Planning Rationale Addendum No. 1

1081 Carling Avenue, Ottawa

**RE: 1081 Carling Avenue, Ottawa
Planning Rationale Addendum No. 1
Zoning By-Law Amendment (D02-02-21-0093)**

Figure 3: Comparison of the original and revised design showing the changes to the setbacks and stepbacks

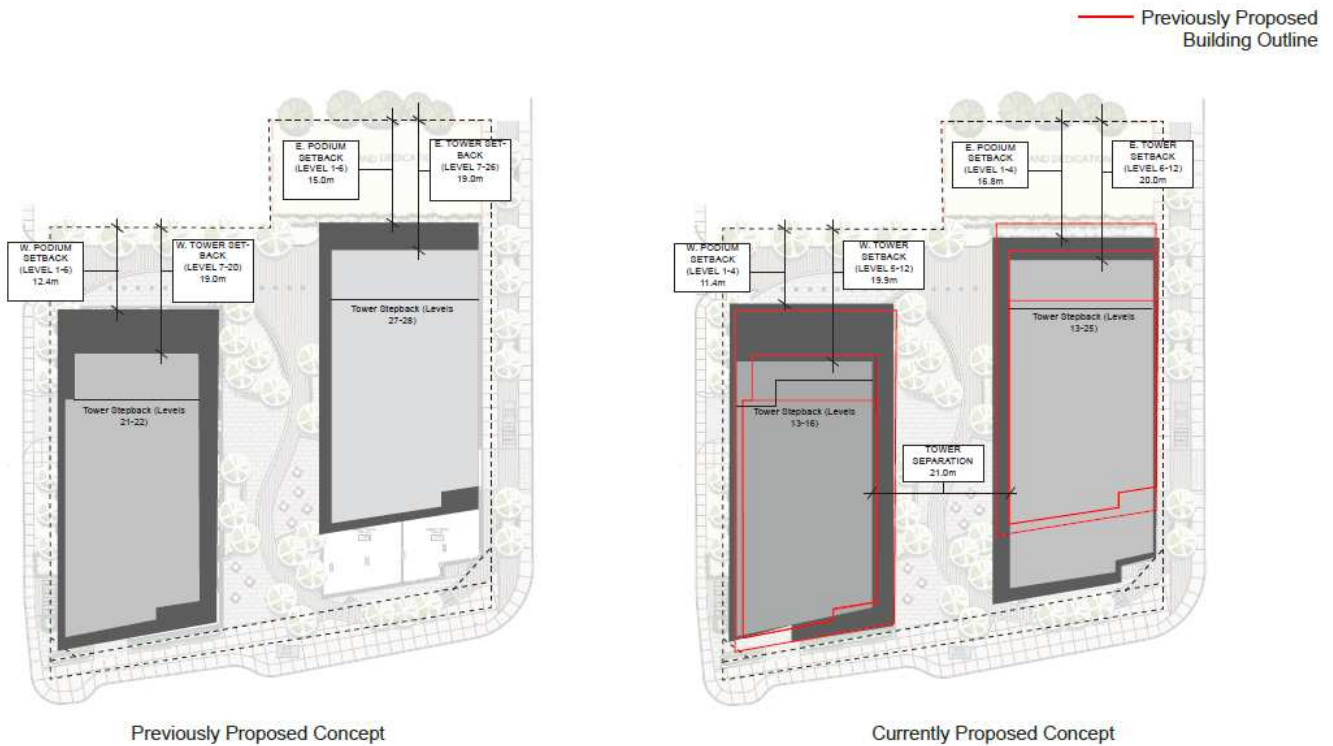
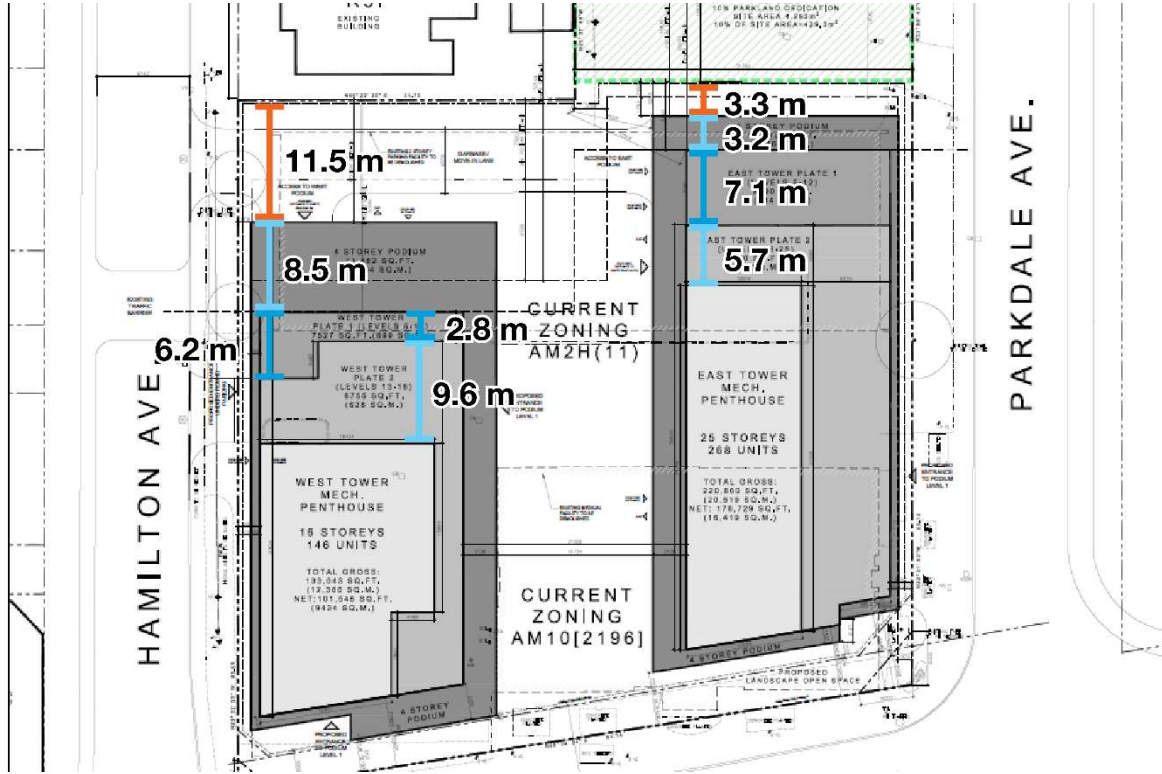
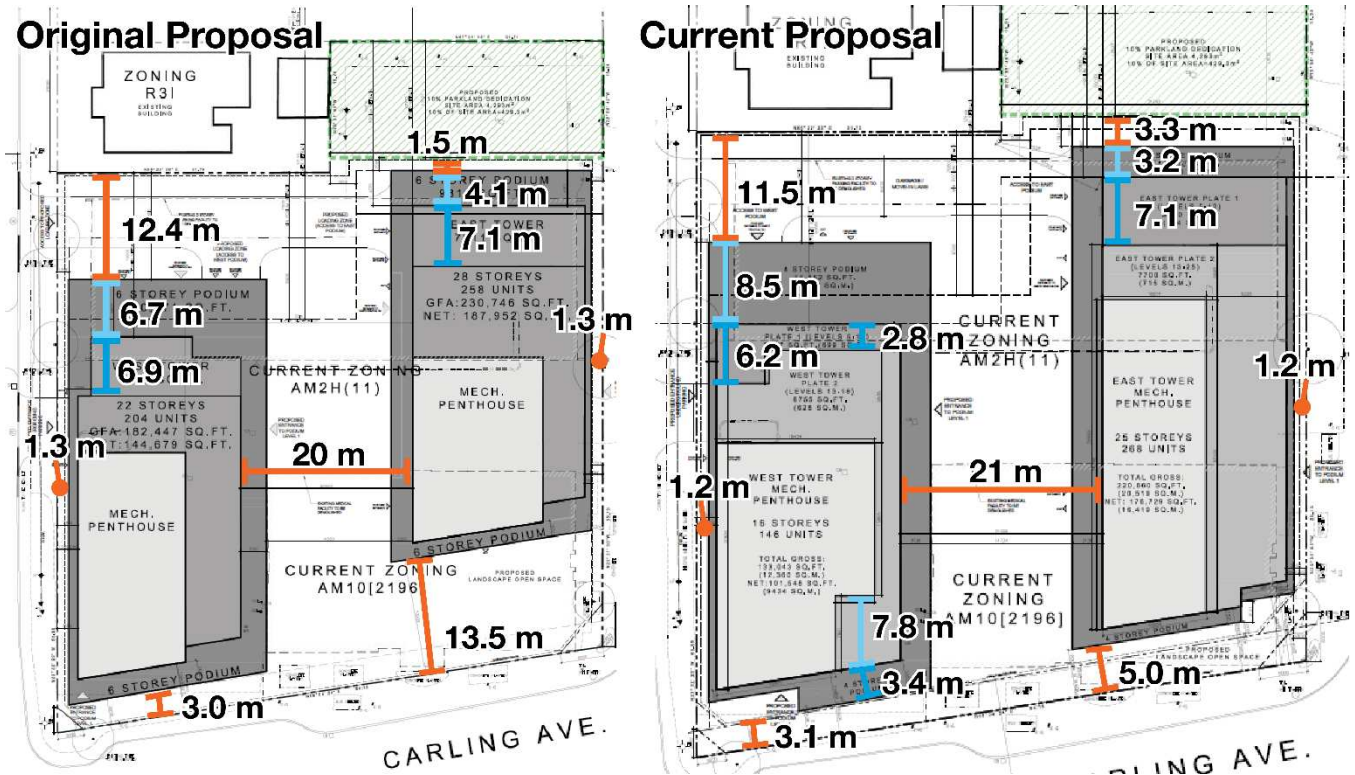
1.1 Transition: Staff have concerns that the proposed development does not provide adequate transition to the adjacent low-rise residential neighbourhood. Transition should be measured from the south side of the 425 Hamilton Avenue property, not from the public lane that is further to the north. It should also be measured based on the existing and planned context of the adjacent low-rise community.

Transition has been addressed and improved through a combination of decreased podium heights, increased setbacks, new stepbacks, decreasing the building heights, and revisions with consideration of the angular plane. Specifically, the following changes were made to improve transition:

- / Reducing the podium heights from six (6) to four (4) storeys;
- / Increasing the rear yard setback for the east building from 1.5 metres to 3.3 metres from the future park (see also Figure 5 for a comparison of the setbacks and stepbacks of the original and current proposed development)

- / Adjusted the tower stepbacks and setbacks:
 - For the west tower:
 - Increased stepback for the podium from 6.7 metres to 8.5 metres;
 - Increased the setback of tower plate 1 from 19.0 to 20.0 metres (from the tower to the northern property line);

- Increased the setback of tower plate 2 from 25.9 to 22.7–26.2 metres (from the tower to the northern property line);
 - For the east tower:
 - Decreased stepback above the podium from 4.1 metres to 3.2 metres to fit more of the podium in the angular plane;

- Increased the setback of tower plate 1 from 19.1 to 20.0 metres (from the tower to the northern property line);
 - Increased the setback of tower plate 2 from 26.2 to 27.1 metres (from the tower to the northern property line);

Figure 6: Current two-tower redevelopment proposal

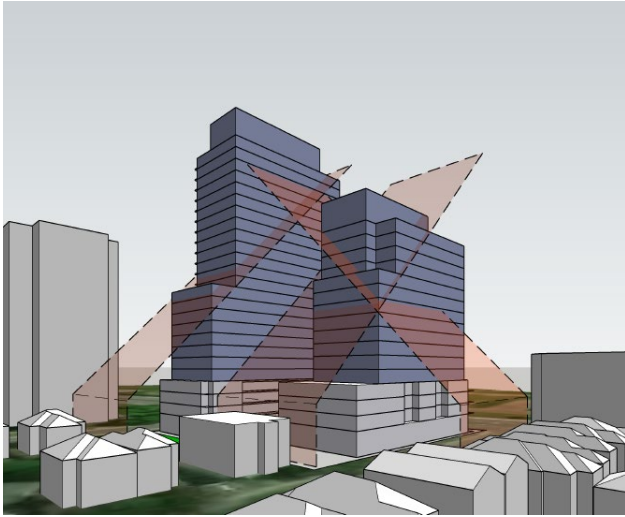
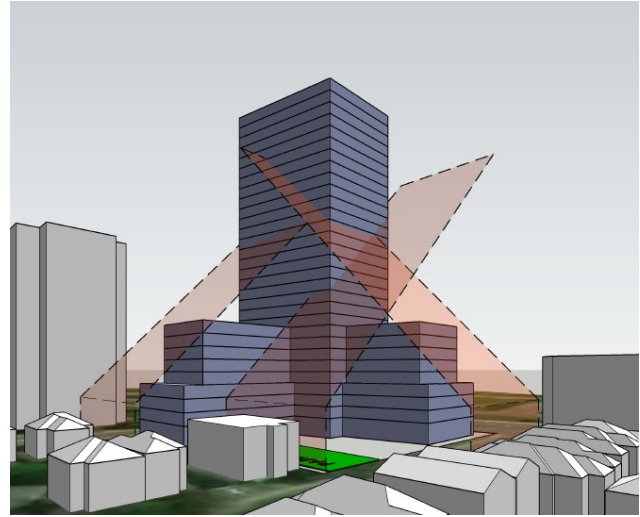
1.3 Built Form/Tower Separation: Staff are not convinced that this site is appropriate for two towers. Please explore alternate development concepts for the site.

The development team reviewed the site's ability to accommodate a single tower. A single tower causes multiple issues, including:

- / In order to maintain transition to the abutting neighbourhood, this scheme resulted in a greater tower height than the proposed development
- / Sun and shadow impacts are more significant as the taller tower casts a longer shadow across more of the neighbourhood; and
- / A one-tower scheme does not permit for phased development and the client has advised us that the market is unable to absorb approximately 400 units at once. In comparison, a two-tower scheme allows for project phasing strategy for better market absorption.

The current two-tower redevelopment proposal is shown below in Figure 6 and the one-tower option that was explored is shown in Figure 7 below.

Pursuing the project as a two-tower design permits phasing, both in terms of the development and for market absorption of the new units. Significant changes to the height, setbacks and setbacks of the building have resulted in an improved transition to the neighbourhood and maintained the required separation of towers.

Figure 10: Revised Sun and Shadow Study for the revised proposal

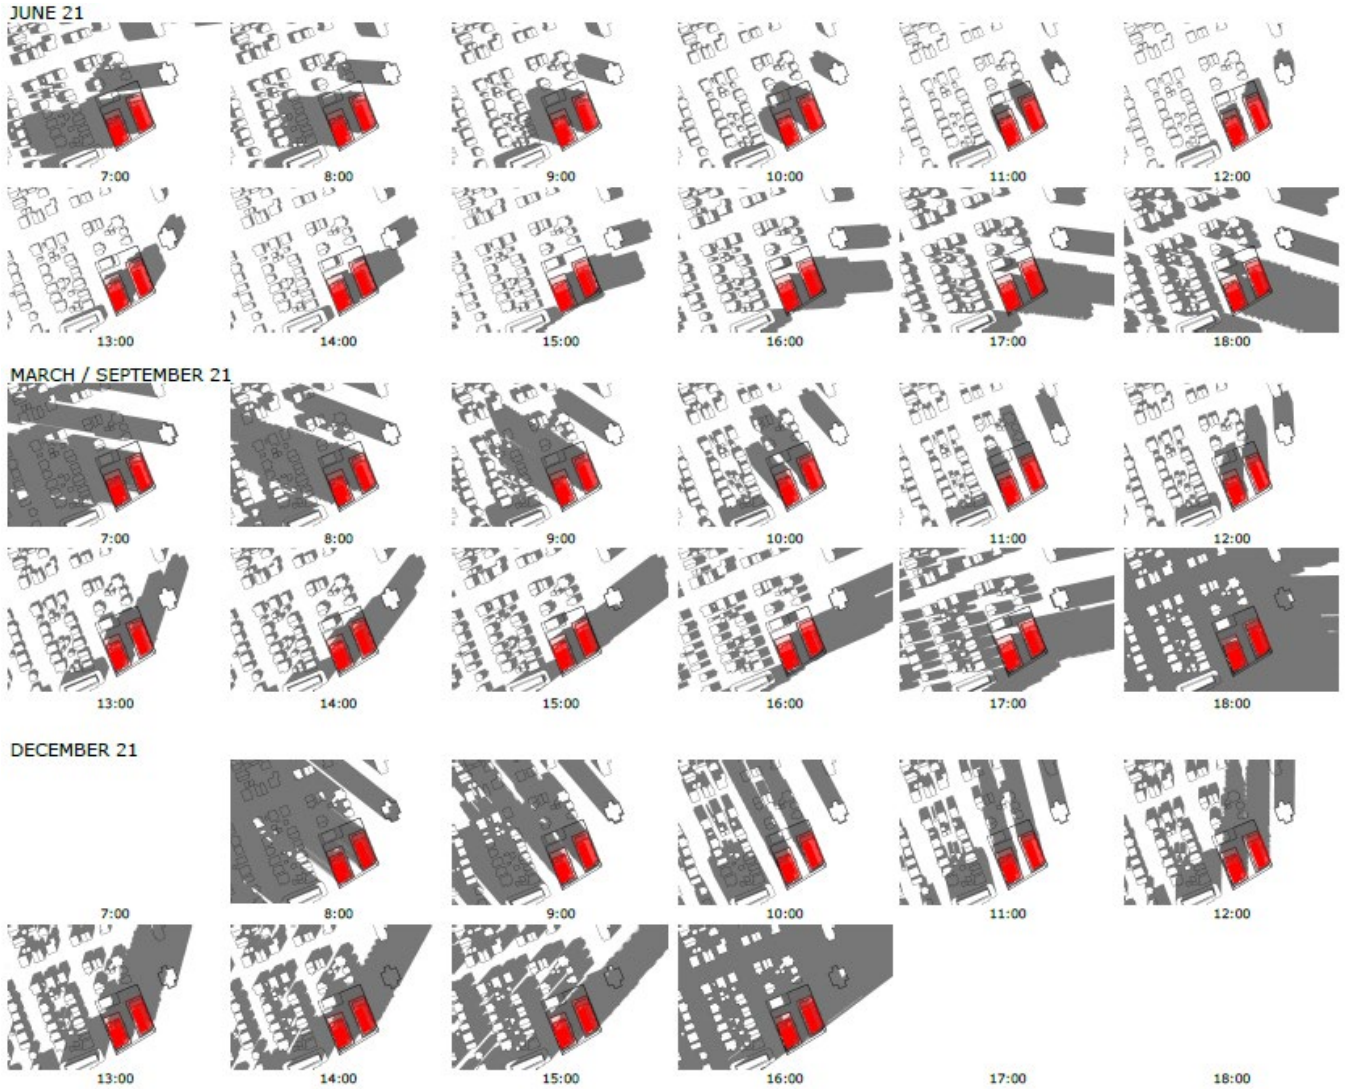
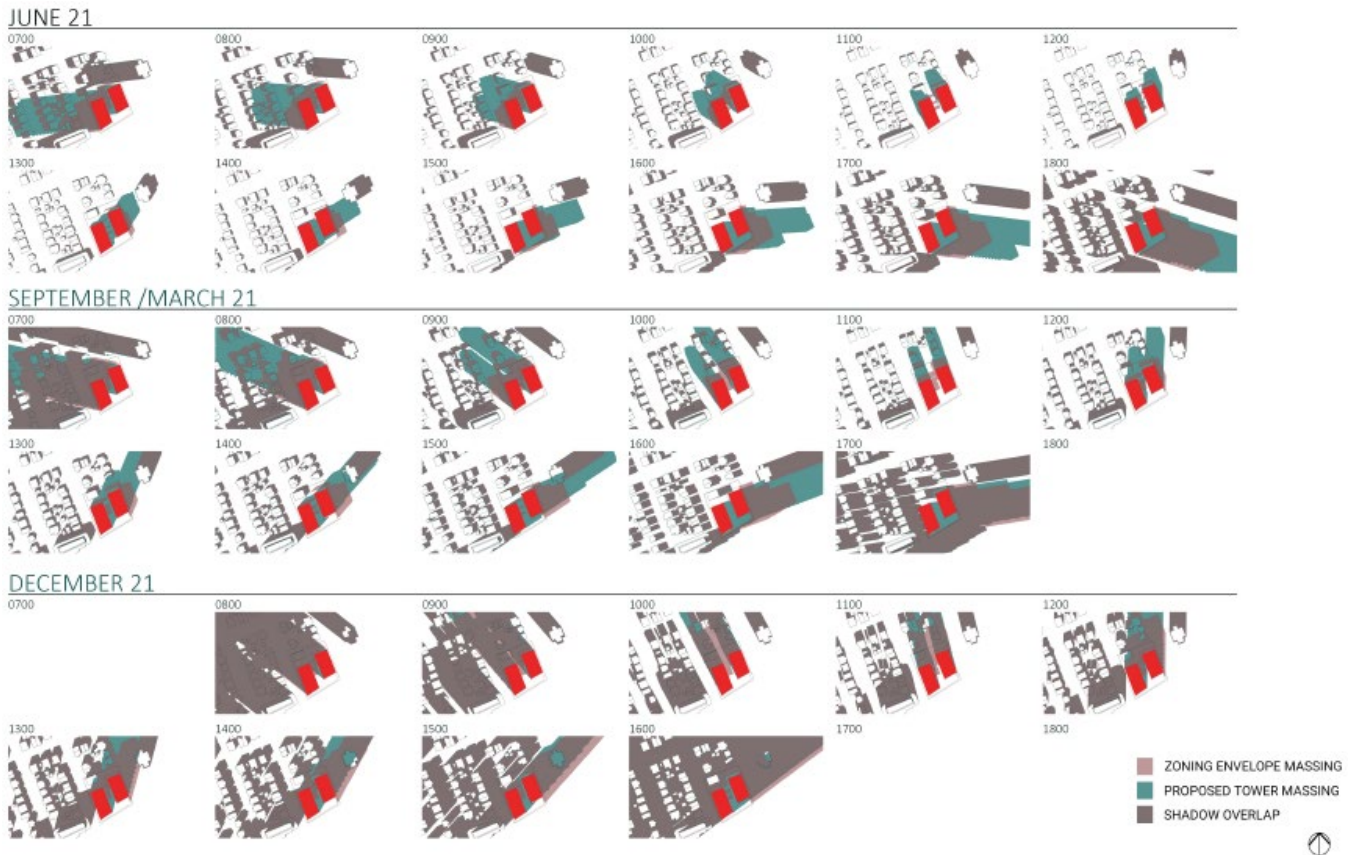
2.7.b.ii: Please explain how shadow impacts have been minimized or avoided, with references to Policies 11 and 14, and references to the submitted Shadow Analysis.

Per policy 11 of section 4.11, a Sun and Shadow Study was included as part of Submission 1 and has been revised to reflect adjustments made to the design for Submission 2. They are both shown below as Figure 10 and Figure 11. The building has been designed to minimize shadow impacts to the surrounding private dwellings and public sidewalks and roads. A point tower, rather than a bar building, is proposed to minimize shadow impacts. Plate 2 of the west tower has a footprint of 628 square metres and plate 2 of the east tower has a footprint of 715 square metres, both of which are lower than the recommended maximum tower floorplate of 750 square metres. Both buildings utilize stepbacks to create a slim profile. For the west tower, plate 1 has stepbacks of 2.8 and 6.2 metres and for the east tower, plate 1 has a 7.1-metre stepback. As well, the low-rise podium height of four (4) storeys ensures that shadow impacts from the podium are minimized. A taller podium would cast larger shadows.

Shadow impacts have been minimized in the latest revisions to the site plan and building design. The revised building design results in fewer shadow impacts due to the decreased height and multiple step backs. The revised design has more slender towers with smaller tower floorplates, minimizing the long shadows cast by the development. As well, the podium on both buildings have been reduced from six (6) to four (4) storeys, which mitigates shadow impacts in the immediate surroundings, including for the adjacent residential neighbourhood. The revised shadow study has been included as part of this resubmission.
